# LAPIS Semiconductor Errata

## ML620Q500H Series

Issue date: May. 19<sup>th</sup> 2016

## 1. Introduction

### 2.1 Power-down/on Procedures

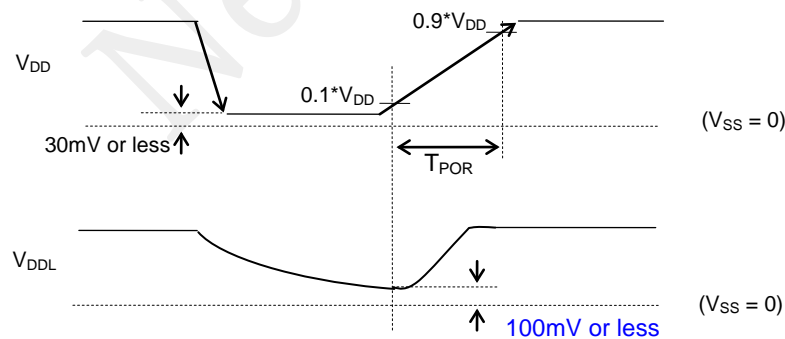
A Power-on procedures and constraints are modified (in Appendix C. of the User's manual).

(Previous procedures and constraints )

(Modified procedures and constraints)

Note:

If VDDL level is 100mV or more over, reset the IC by RESET\_N pin after power-on.
